**ACME TOWNSHIP PLANNING COMMISSION MEETING
ACME TOWNSHIP HALL
5320 US-31 N, Williamsburg MI 49690
(Former Acme Laundromat at US-31 & Bunker Hill Rd)
May 13th, 2019 7:00 p.m.**

1. SPR 2019-04 – Sky mint Medical Marihuana Provisioning Center (PZR 2019-07)

6140 Arnold Rd. Storm Water Control Design

Revised May 9, 2019 as per review comments from Acme Twp Engr.

SLOW RELEASE STRUCTURE

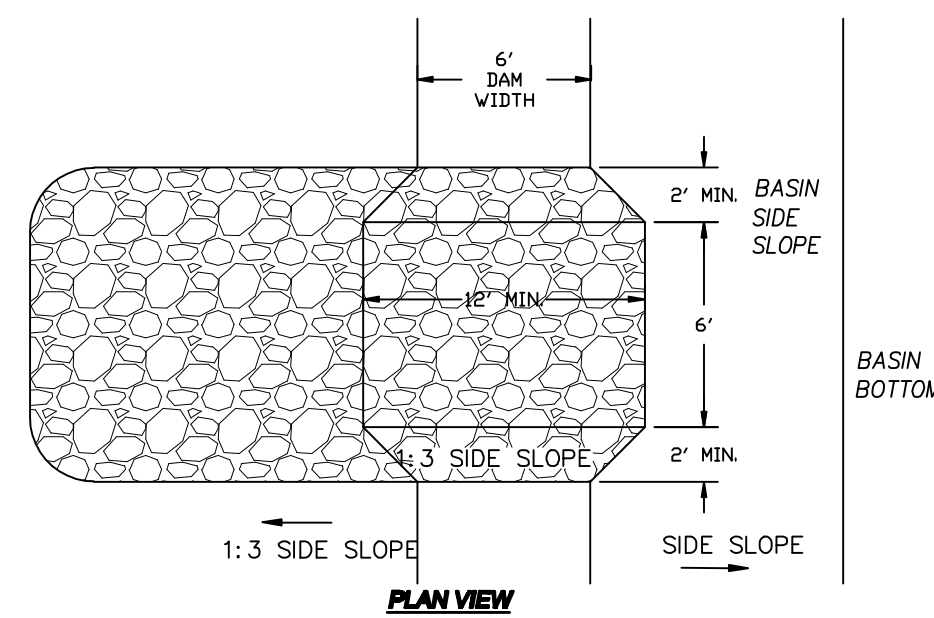
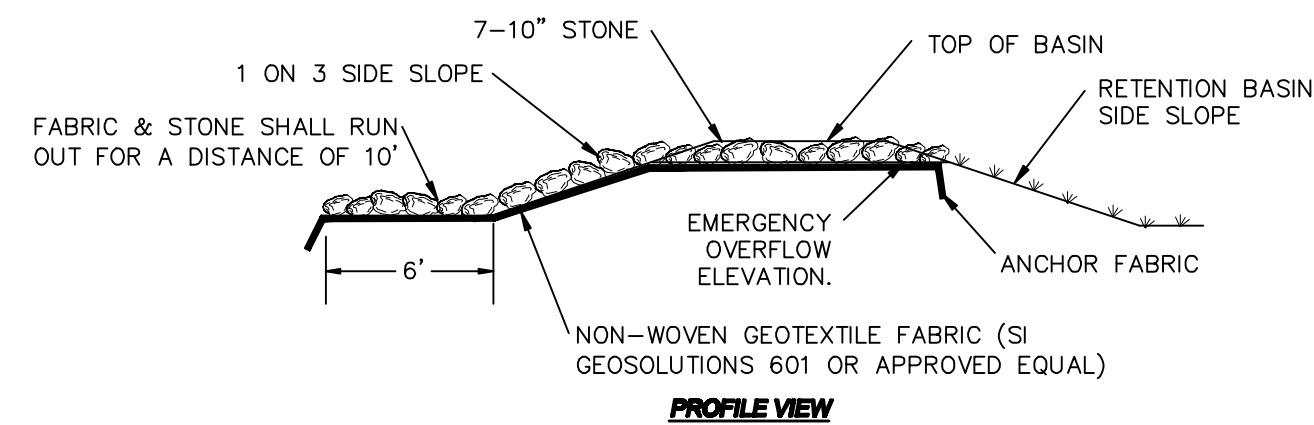
The detention pond has a volume of 2,135 c.f. at an elevation of 739.75 (1.25 feet above the bottom of basin). Therefore the plans have been revised to show the orifices at or above the elevation of 739.75. (See detail, sheet C5).

The detention pond has a volume of 2,135 c.f. at an elevation of 739.75 (1.25 feet above the bottom of basin). Therefore the plans have been revised to show the orifices at or above the elevation of 739.75. (See detail, sheet C5).

4. The detail on sheet 5 has been revised to reflect a Corrugated Metal Riser Pipe.
5. A maintenance note has been added to Sheet 4, stating that the sediment in the forebay will be removed when it reaches 50% of the depth.

6140 ARNOLD ST.
PHOTOMETRIC PLAN
1"=20'-0"

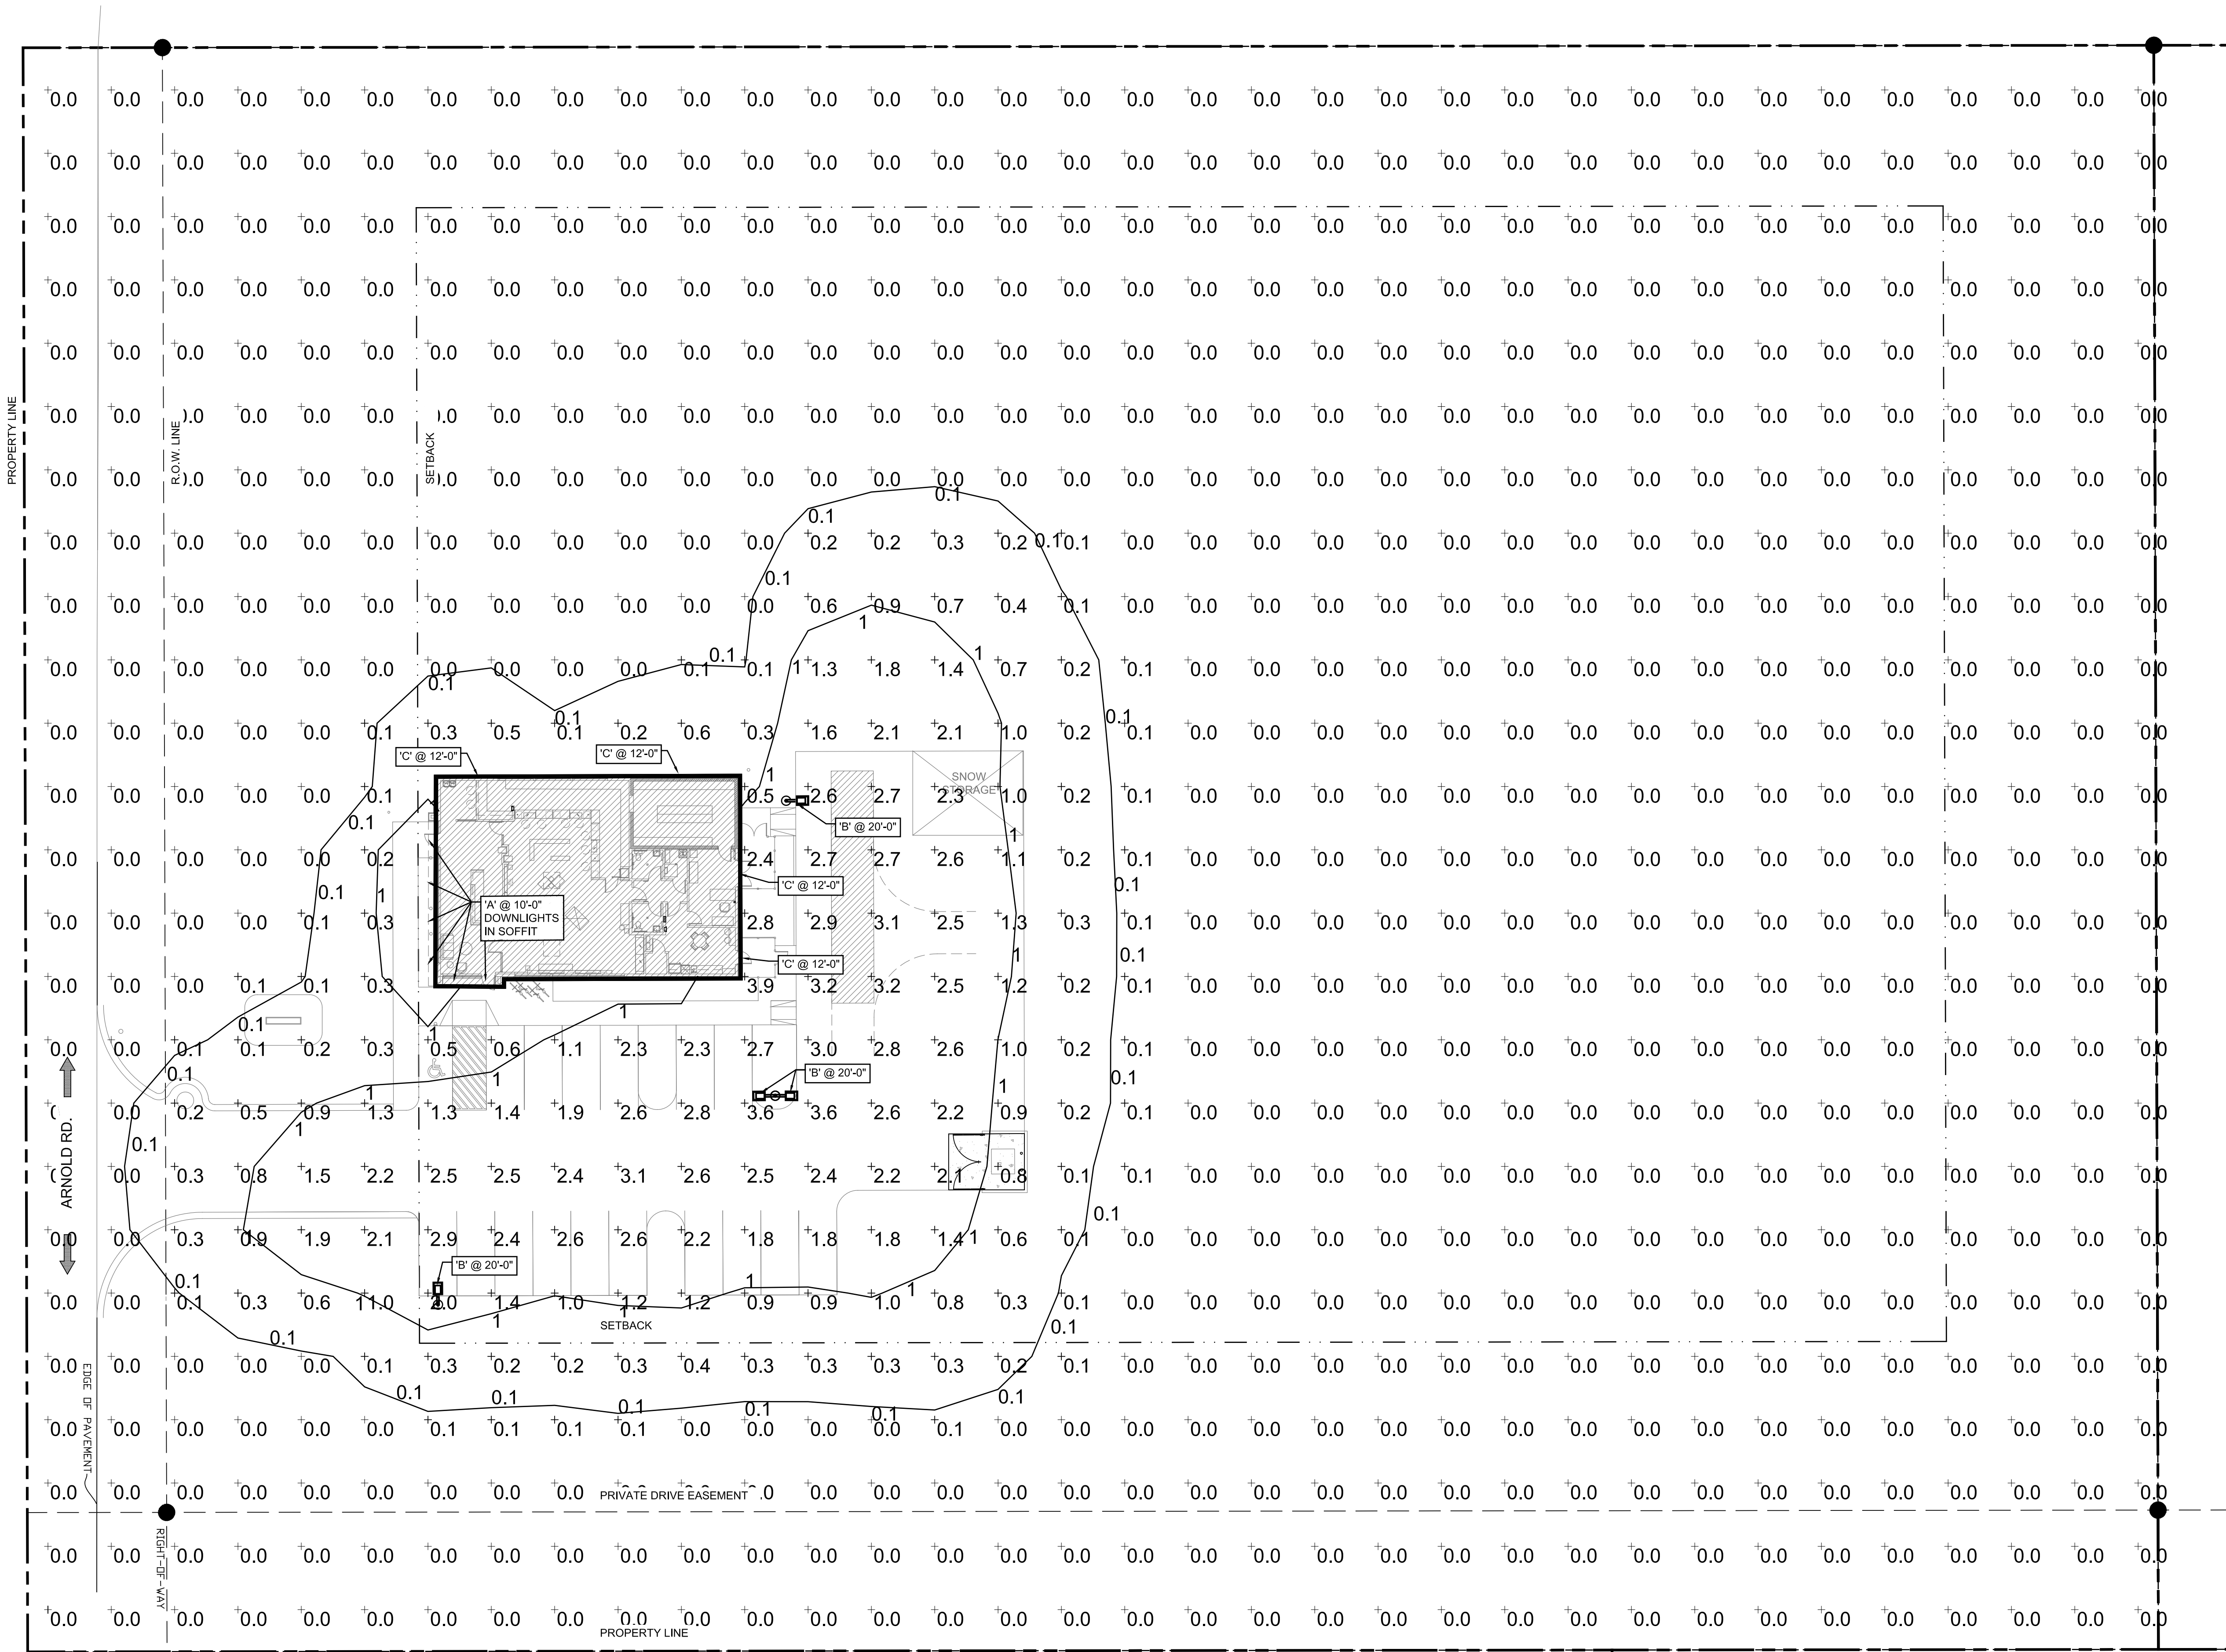
- 3. Remove the wall pack lighting on the south and north facades of the building;**
- 4. All exterior lighting shall be shut off outside the hours of operation once the staff is no longer present except for the wall packs on the east façade, and one soffit light above the south entry and one soffit light above the west exit.**

3. *Remove the wall pack lighting on the south and north facades of the building;*
4. *All exterior lighting shall be shut off outside the hours of operation once the staff is no longer present except for the wall packs on the east façade, and one soffit light above the south entry and one soffit light above the west exit;*
